Response to Technical Review Comments

Clear River Energy Center and Burrillville Interconnection Project

**Re: Clear River Energy Center, LLC
Burrillville RI
Application No. 17-0079**

Technical Review Comments of Documents Received by RI DEM on April 4, 2017

Path: C:\Users\SDeHainaut\ESSGROUP\Documents\GIS\Inventory\108_Abutters_Fig02_SheetSet.mxd
 Drawing Date: 9/19/2017 Author: SDeHainaut
 © 2017 ESS Group, Inc.

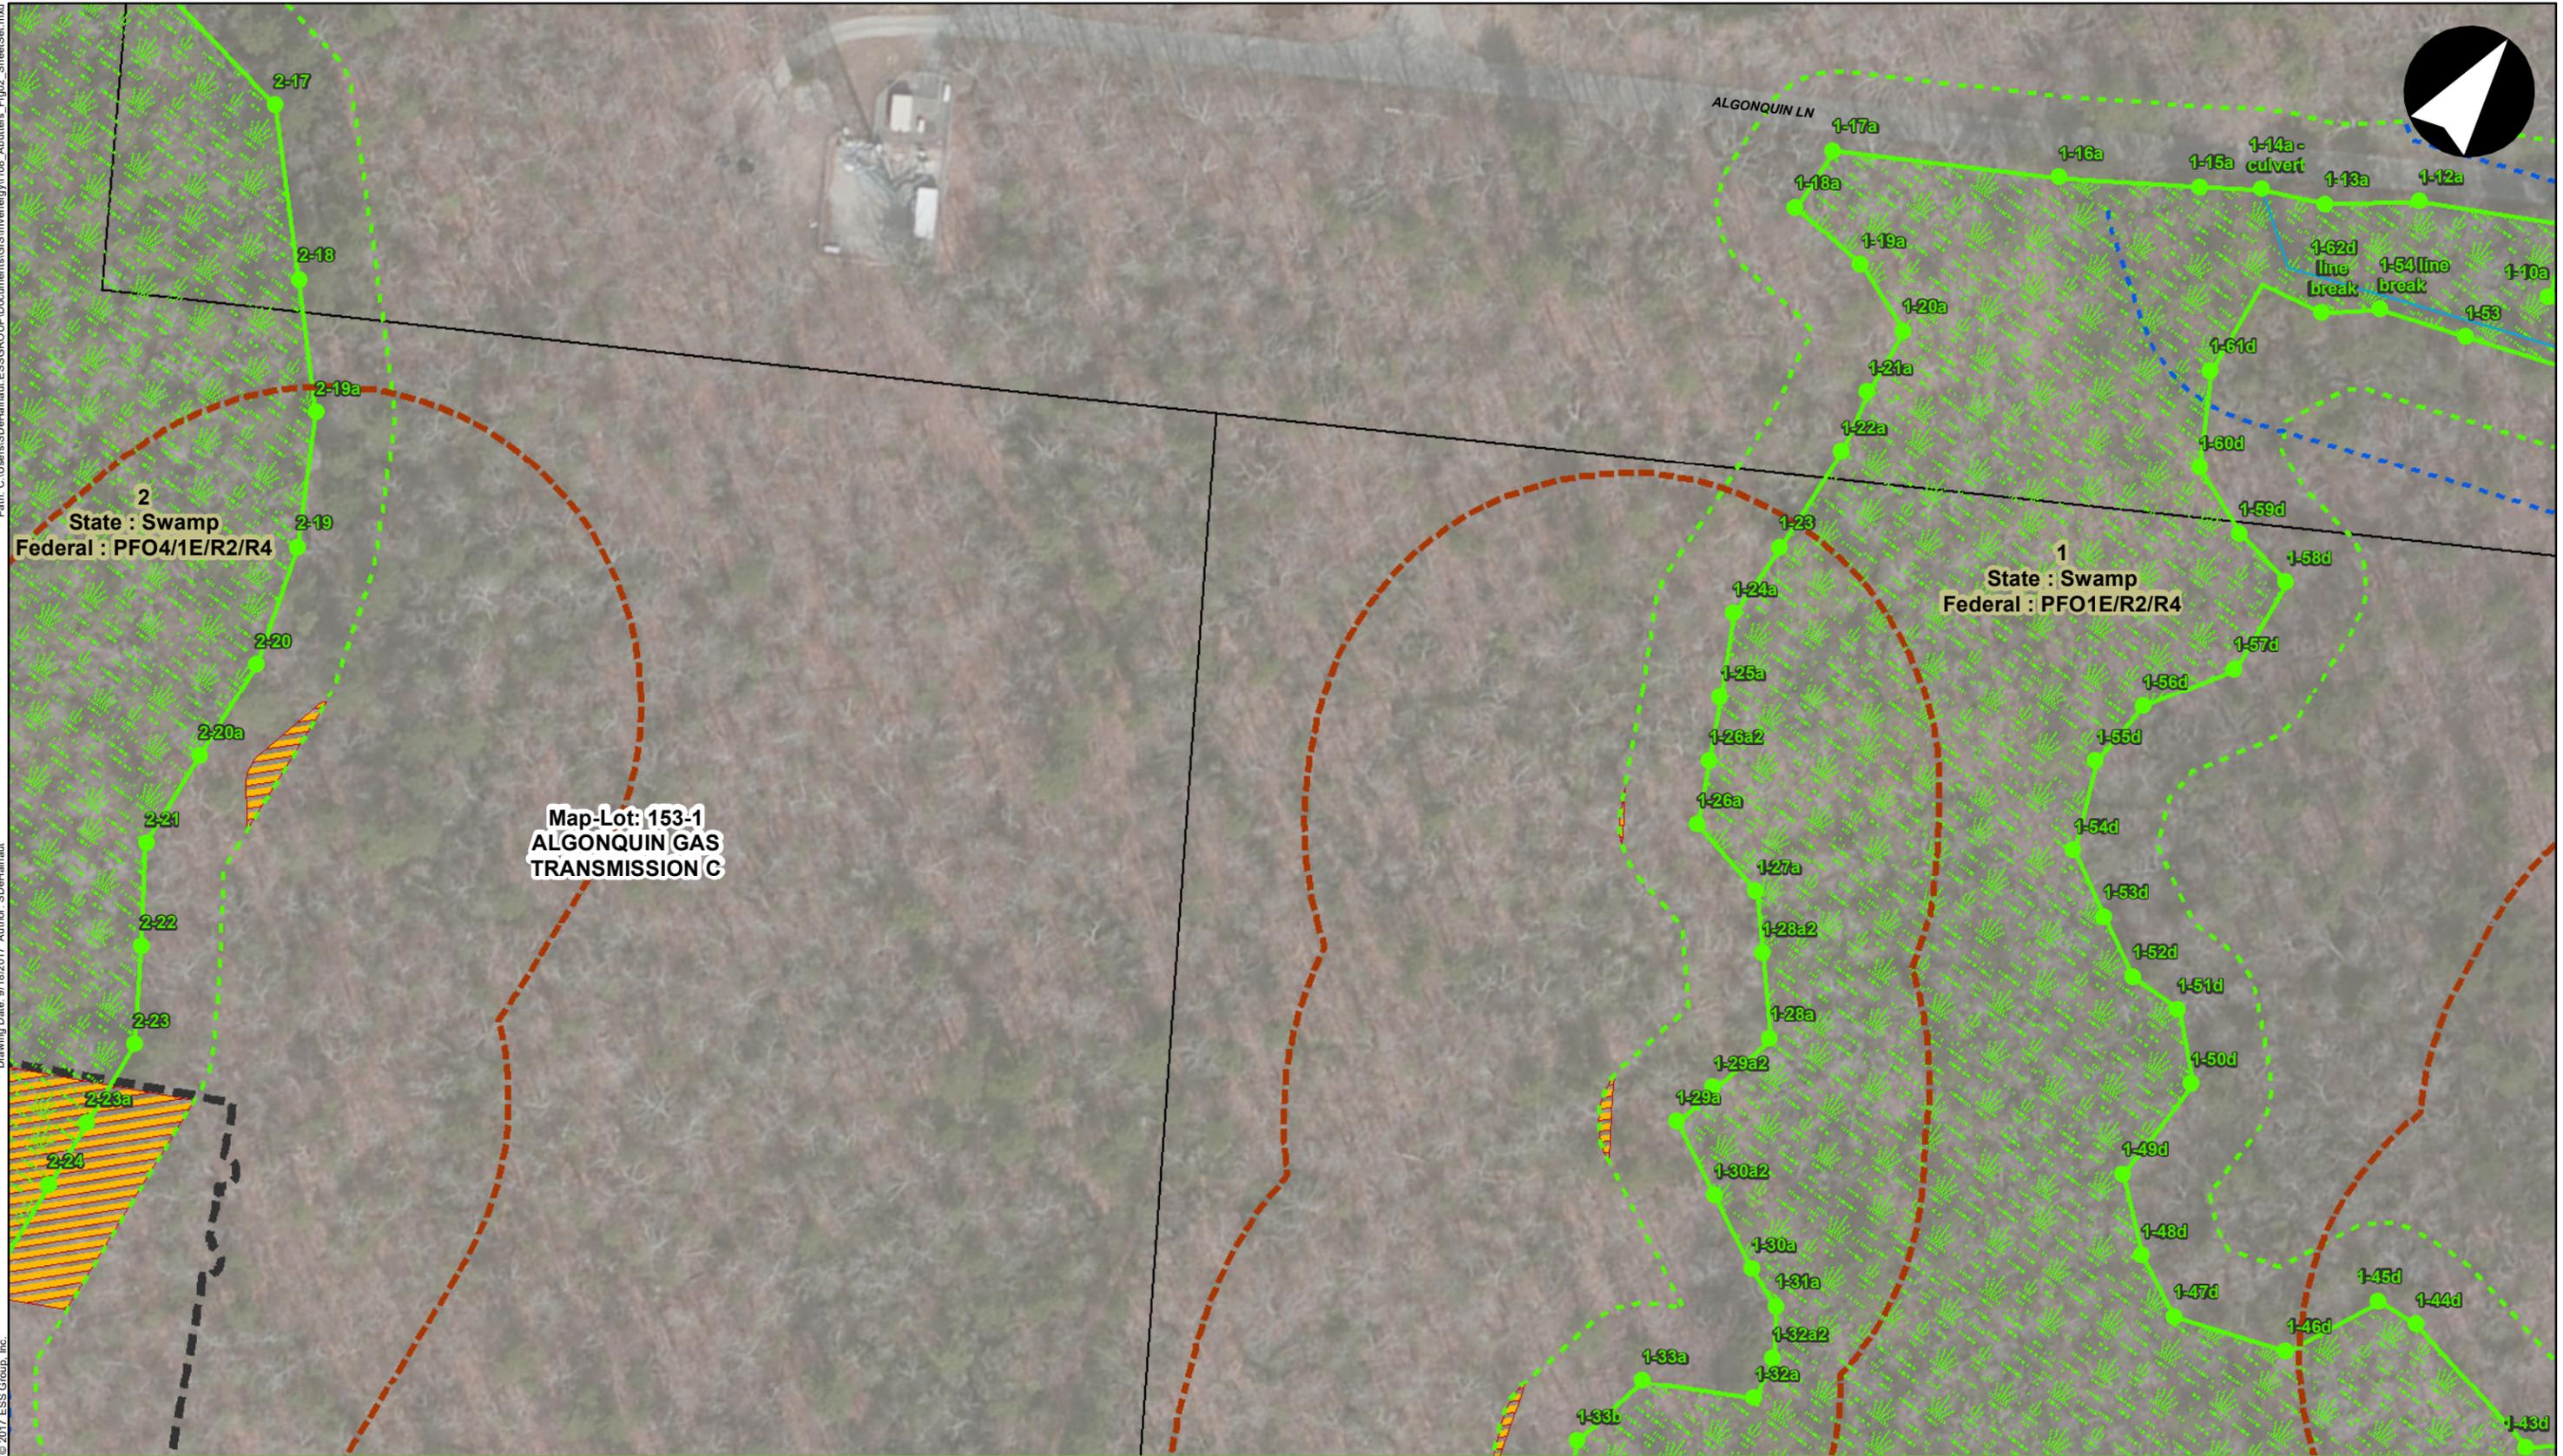
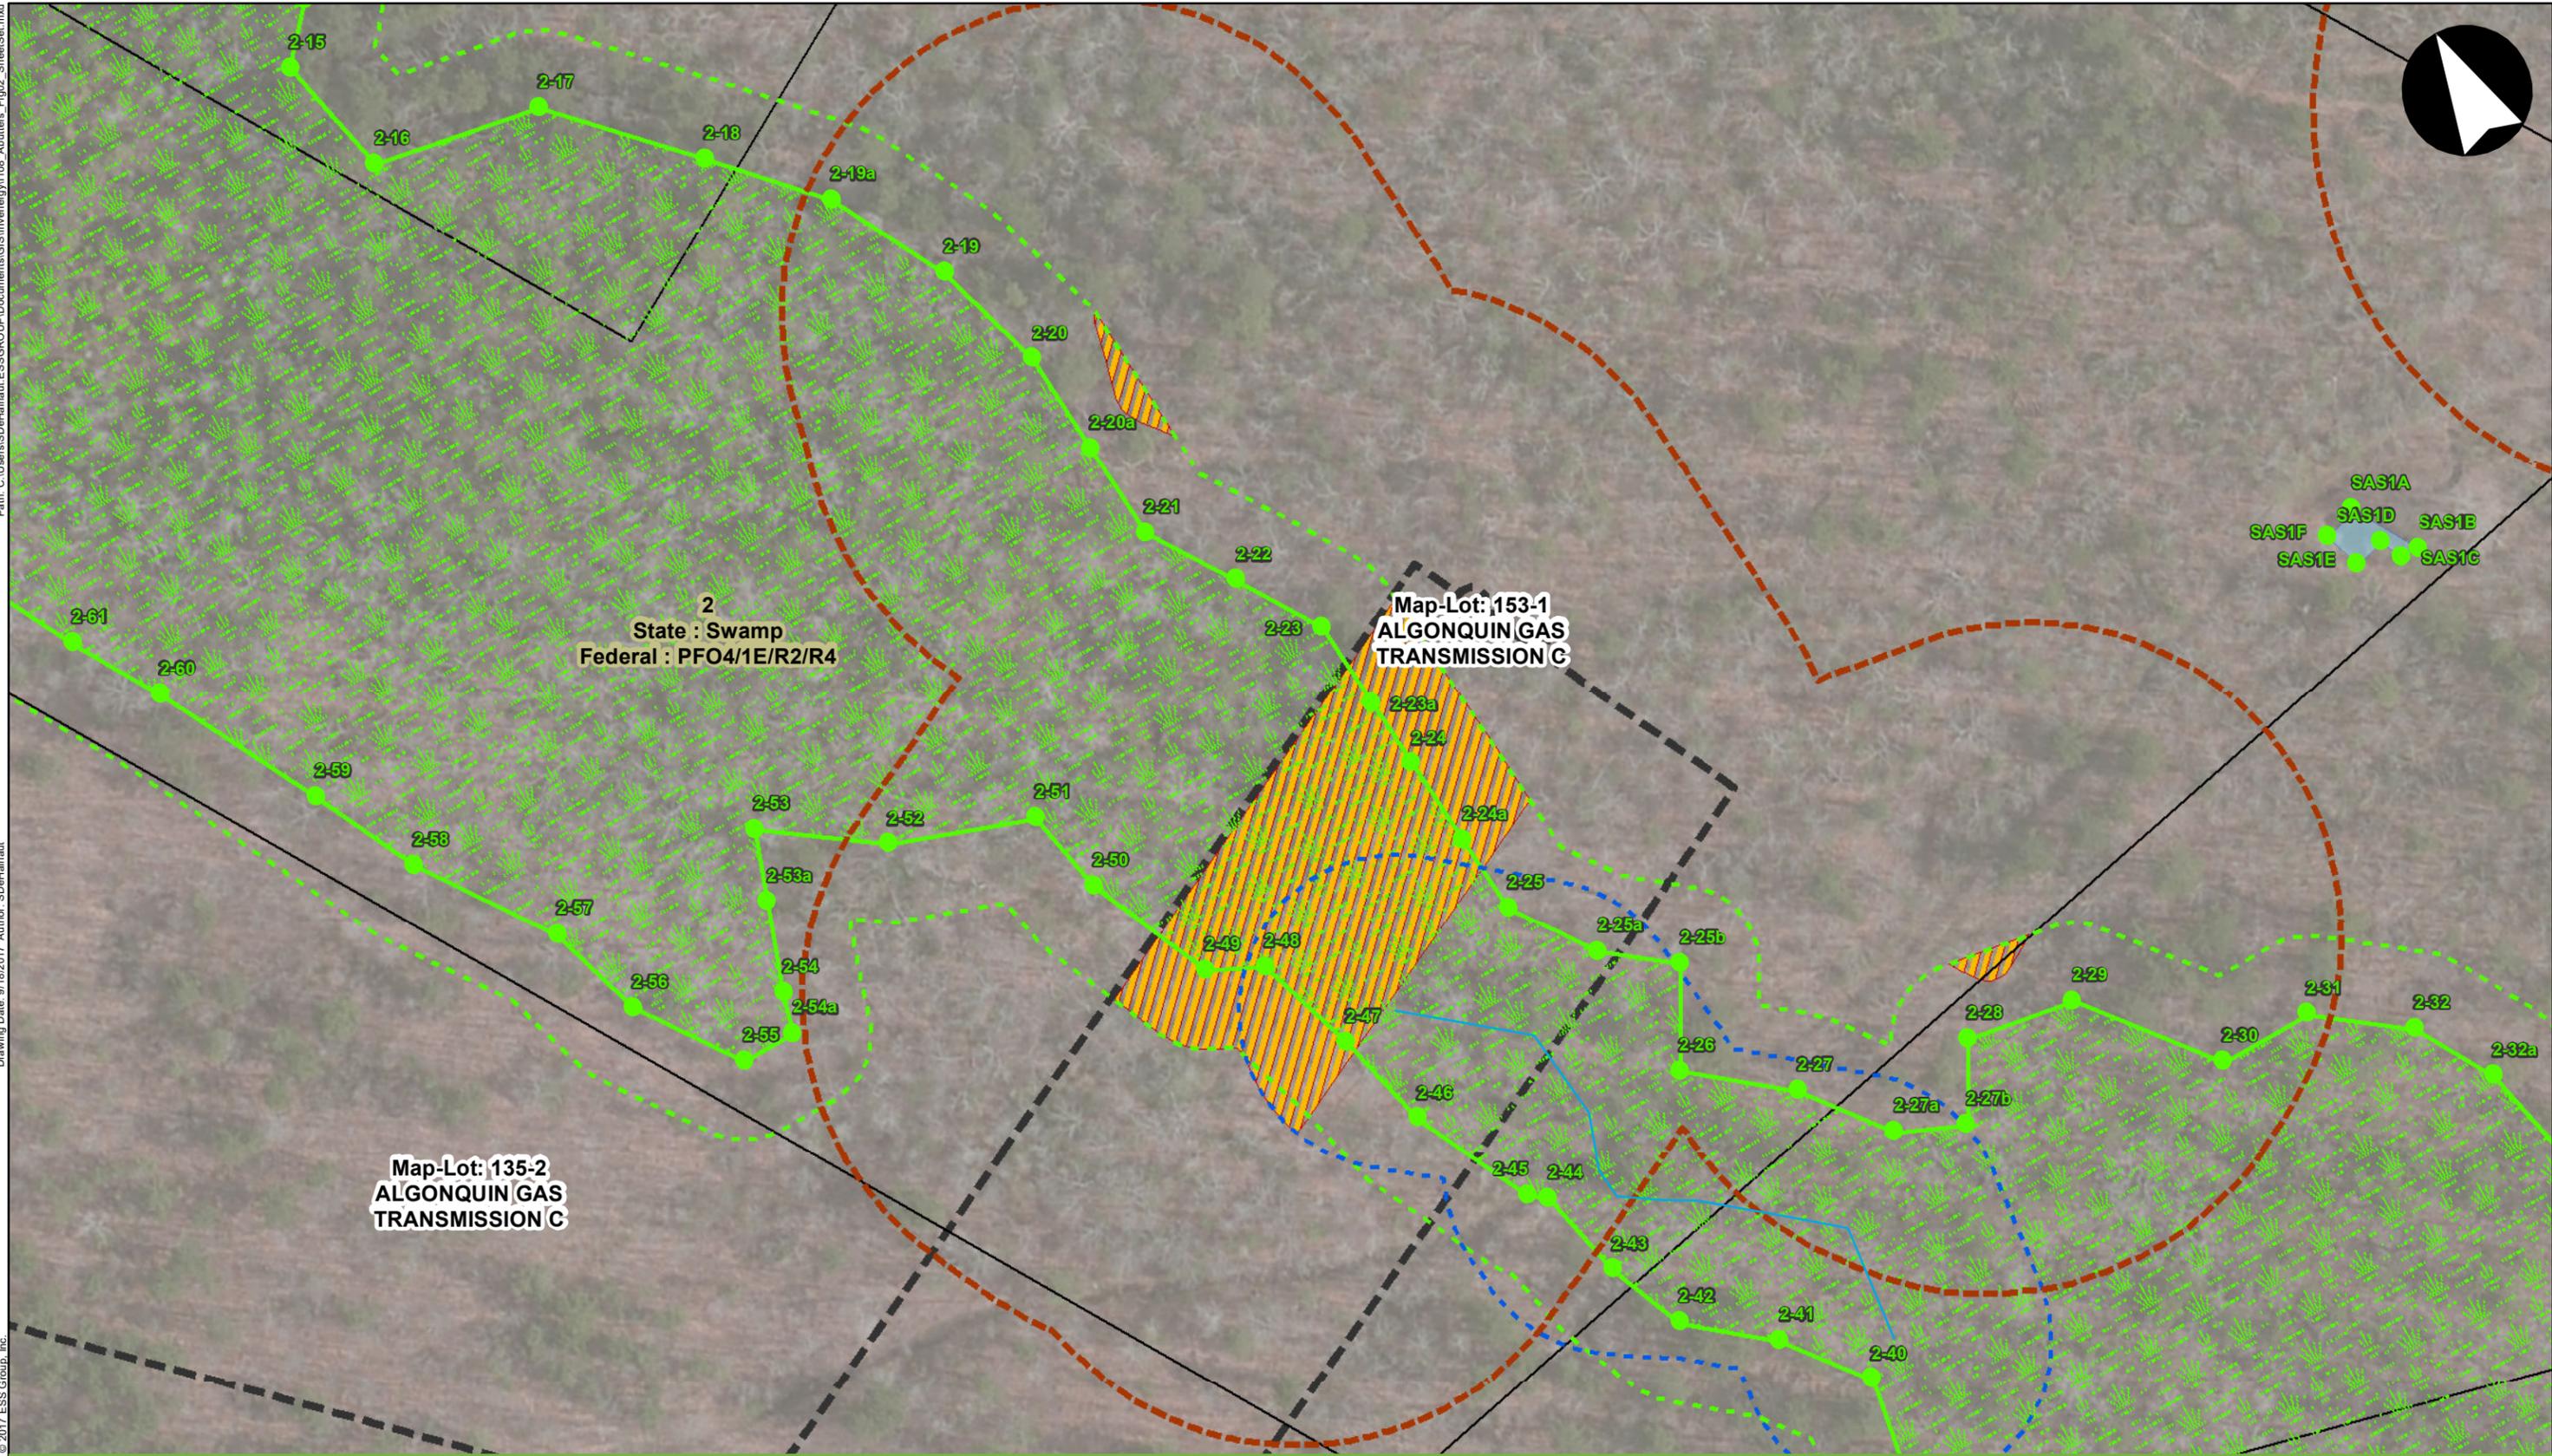
12. The Abutters Maps show project impact area, but the wetland is not identified on the various sheets. There is therefore no way to confirm if the maps are correct. Please clearly depict all wetland limits on the 200-foot radius maps and identify the wetlands similarly to how they are identified on the plan set.

Response: The abutters maps have been revised to depict all wetlands, and depicted wetlands have been labelled in a similar manner to the plan set (see Exhibit 2).
